PLAN COMMISSION AGENDA
January 14, 2019

Eau Claire Plan Commission 1/14/19 Agenda Items

STAFF REPORT

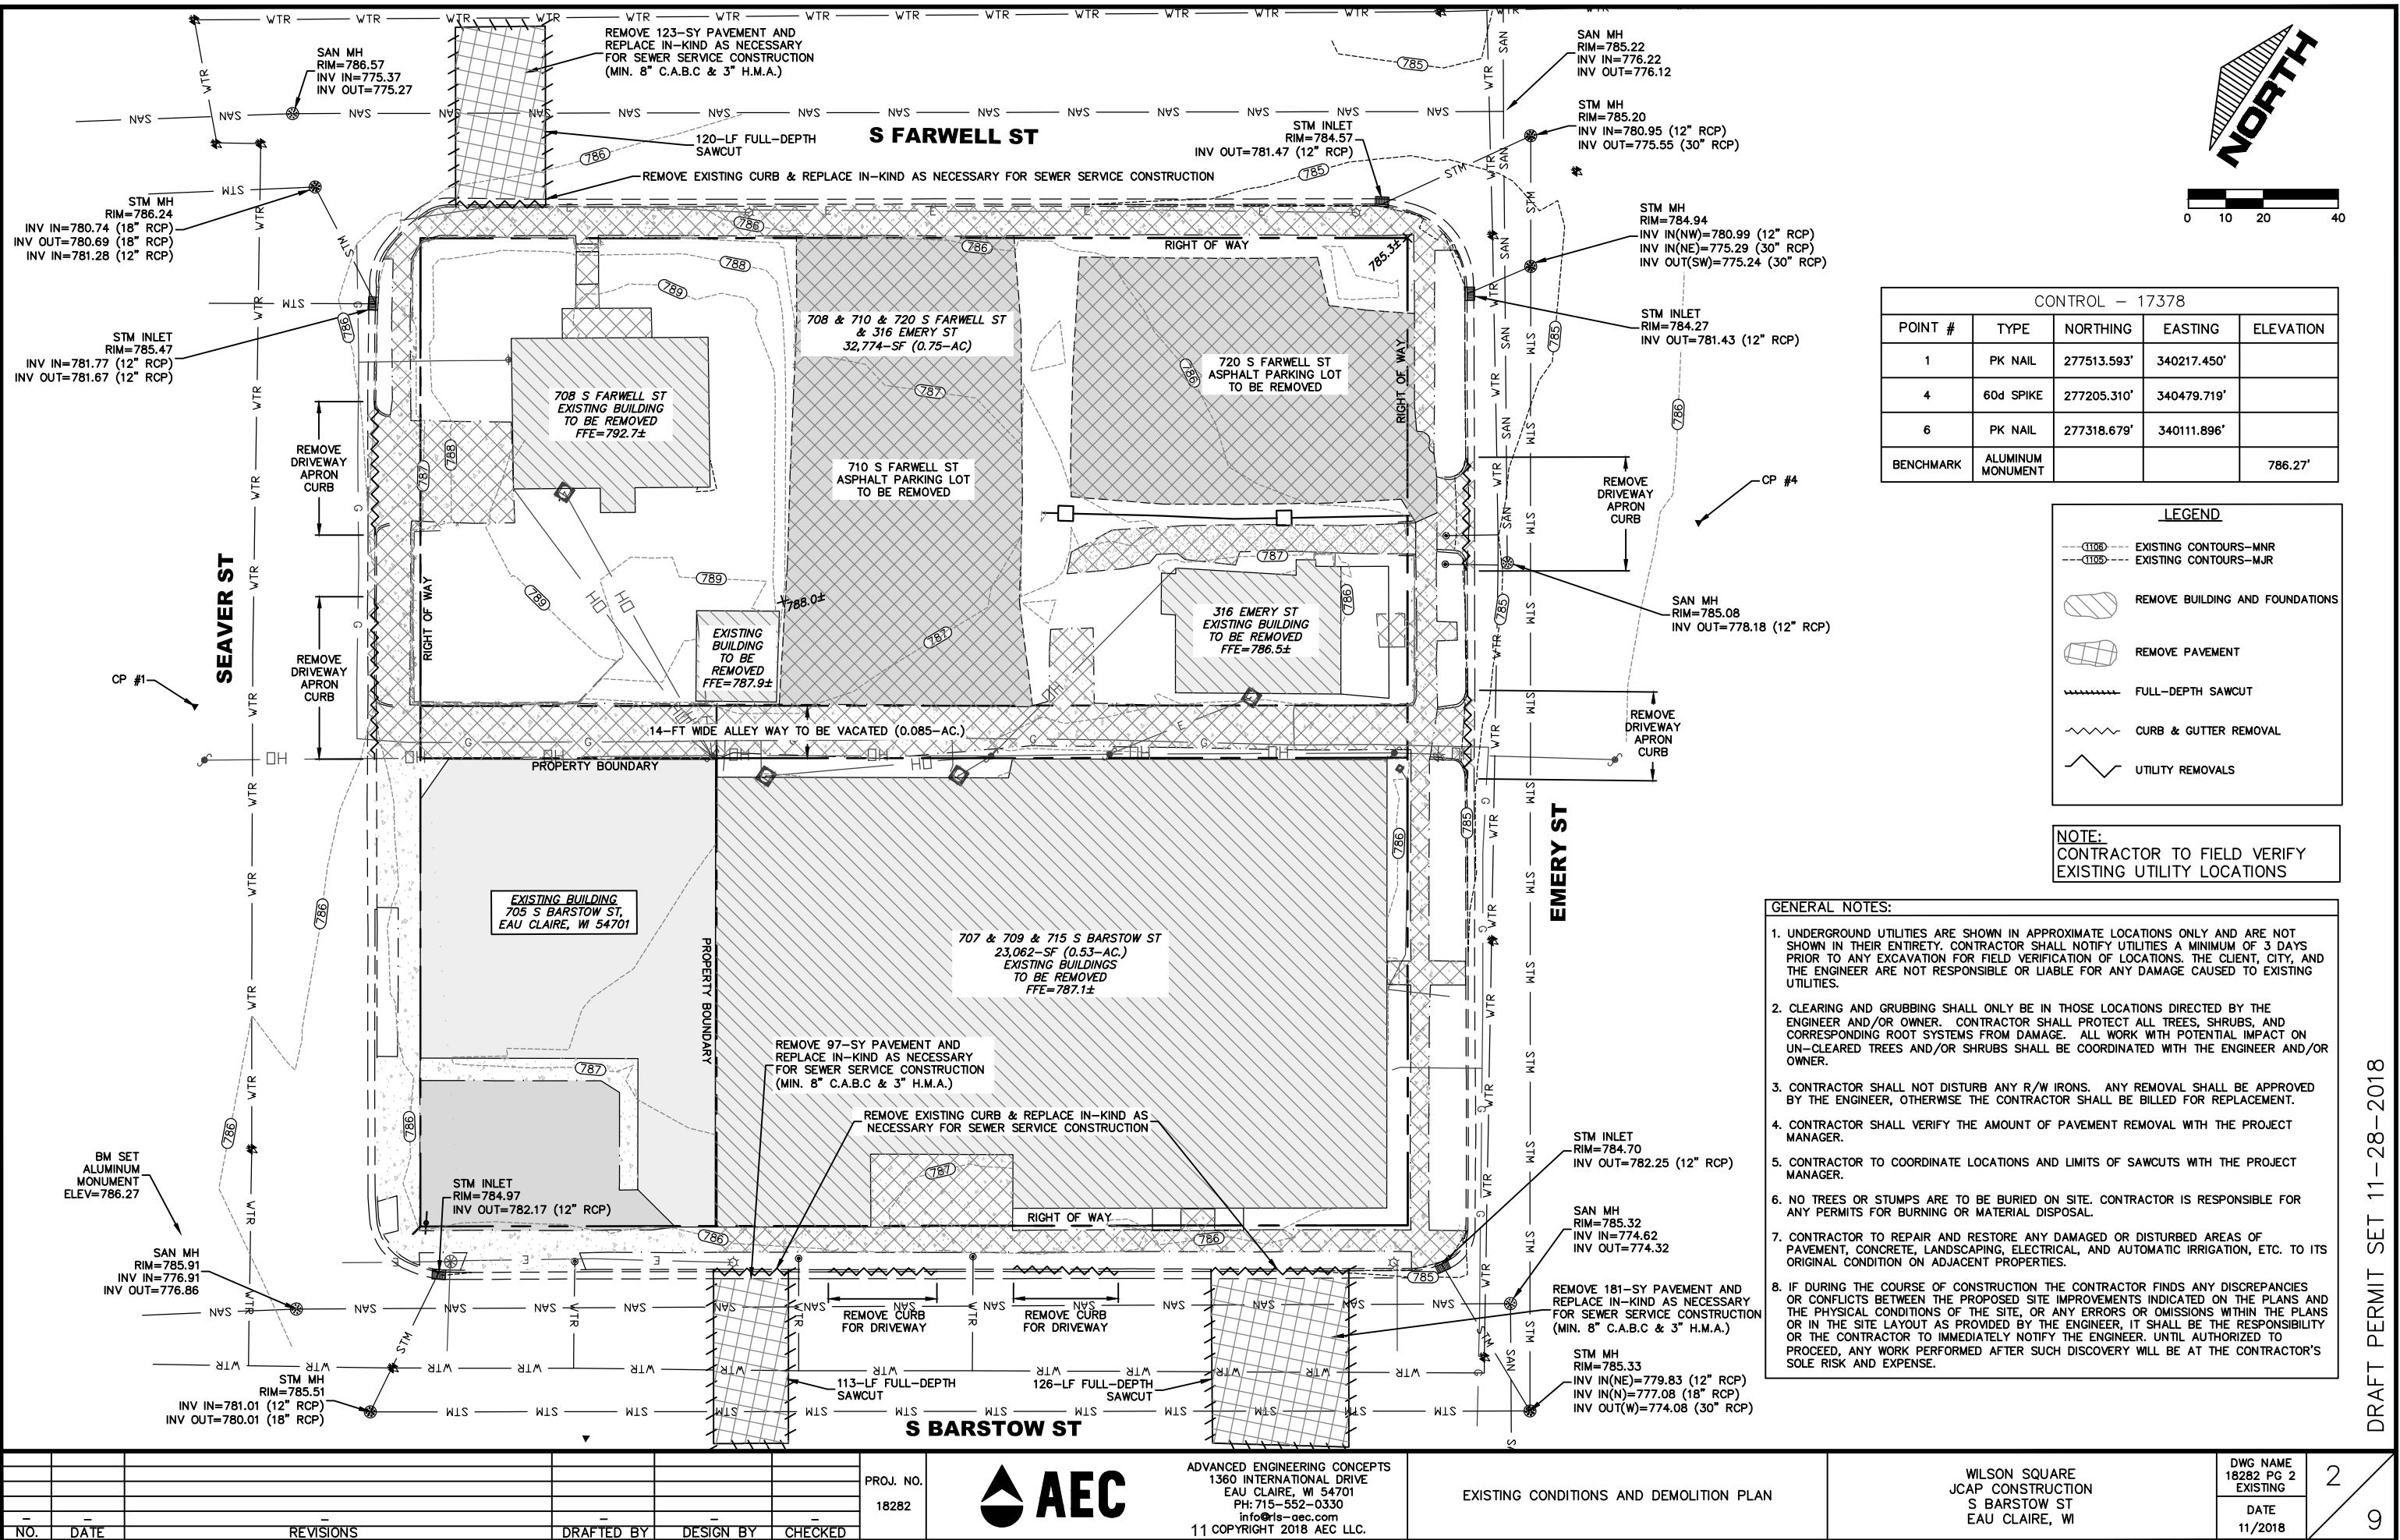
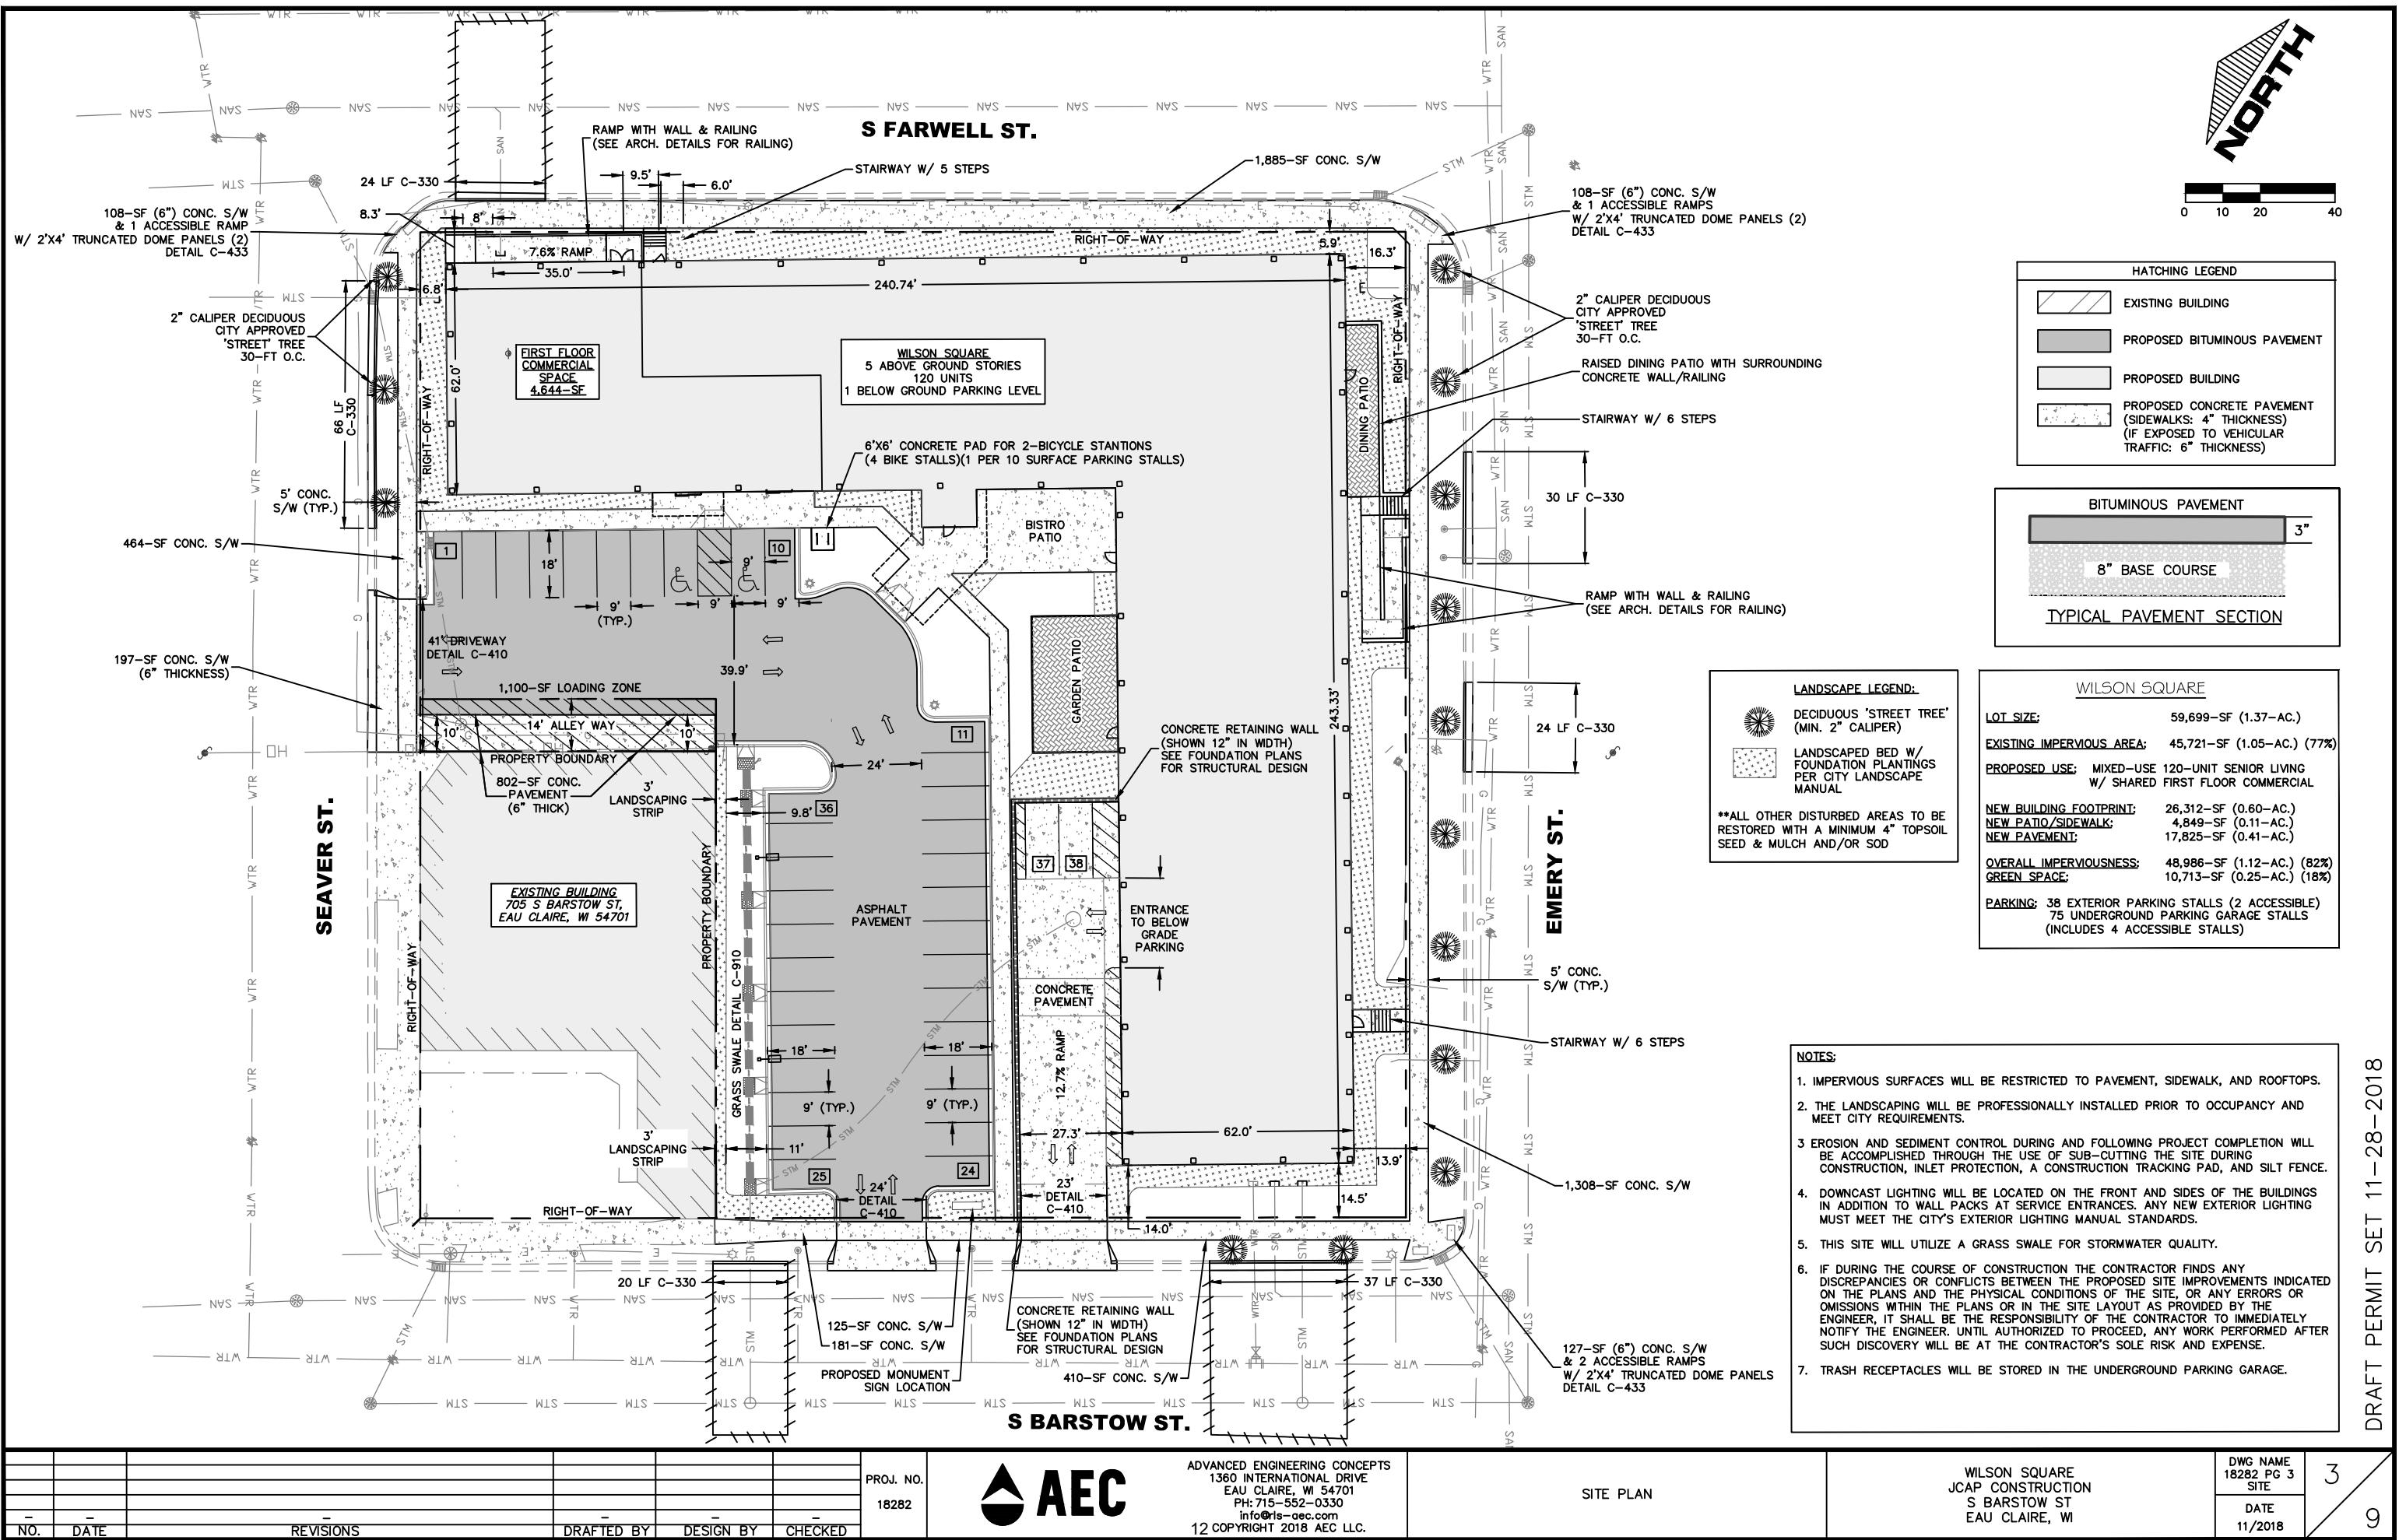
Storm water best management practices (BMP's) are required to improve runoff water quality. A bio-filtration swale is proposed as the water quality BMP. Materials submitted with the site plan indicate that in this application these units are calculated to remove approximately 45% of Total Suspended Solids. The threshold for redevelopment BMP's identified in NR151 is a 40% reduction in Total Suspended Solids. The proposed facility will meet that requirement for the site. The proposed method of handling storm water runoff is to sheet flow runoff across the parking lot into a grass bio-filtration swale that discharges to the drainage system in South Barstow Street. Storm water runoff from the rooftops will be piped directly into the public storm sewer system via three separate connections. The proposed BMP is adjacent to an existing basement on an adjacent parcel. Measures will need to be taken to protect the adjacent structure from runoff infiltrating from the BMP. Protective measures may include sealing the exterior wall of the existing foundation, extending the infiltration media below the WQ BMP to an elevation below the basement slab and the frost line, lining the BMP below the engineered media and drain, a combination of these measures, or other measures designed for similar intent.

Parking related to the commercial development will have access to a surface parking lot from both Seaver Street and South Barstow Street. The plan proposes a 24-foot curb cut on each street for driveway access to the surface parking lot. A second 23-foot curb cut is proposed on South Barstow Street, east of the surface lot driveway to access the proposed underground parking. The driveway approach to Seaver Street needs to align with the existing public alley. Using the alley as access to the parking lot is a permitted use, however, it will be treated as a driveway within the alley (similar to a driveway crossing a boulevard) and will be the responsibility of the parking lot owner to maintain the pavement, clear snow, and replace the pavement as needed.

1. City of Eau Claire Engineering Department approval of drainage calculations and drainage plan.
2. Details showing method to protect the adjacent basement from water quality BMP infiltration.
